ON-SITE SEWAGE DISPOSAL SYSTEM
HOWARD COUNTY HEALTH DEPARTMENT
BUREAU OF ENVIRONMENTAL HEALTH
3525-H ELLICOTT MILLS DRIVE, ELLICOTT CITY, MD 21043

SUBDIVISION: HBL Properties LOT NUMBER: 2

ADDRESS: 14640 Old Frederick Road PROPERTY OWNER: Anderson

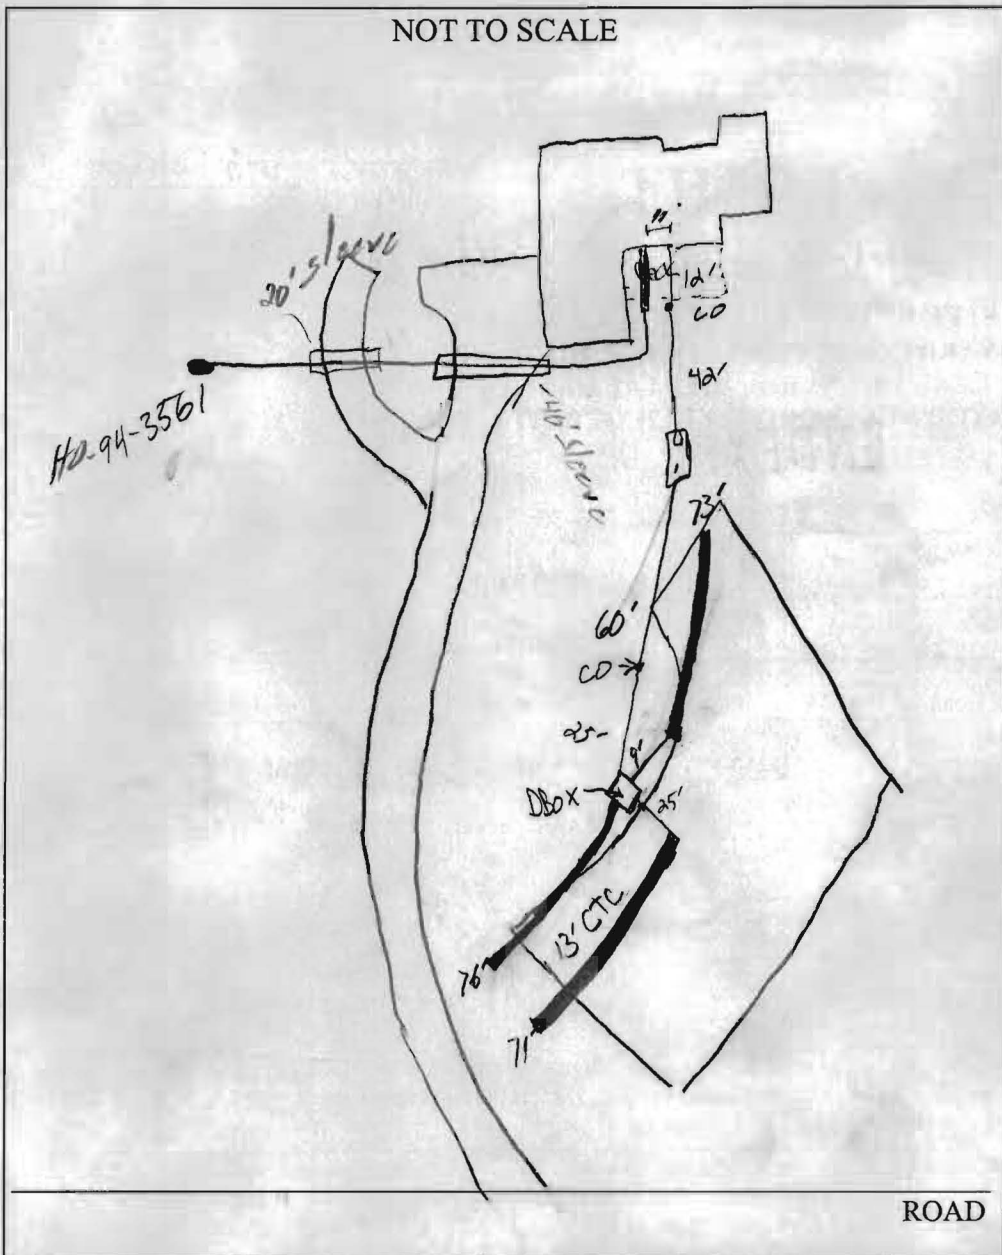
PRE-CONSTRUCTION 12/29/03 - SRA staked, contour flatter than shown. Install (3) 70' trenches w/ D.B. actually out of SRA

INSTALLATION on high side (SO) 1/16/04 tank + (3) 70' + trenches installed ok to cover all work KB
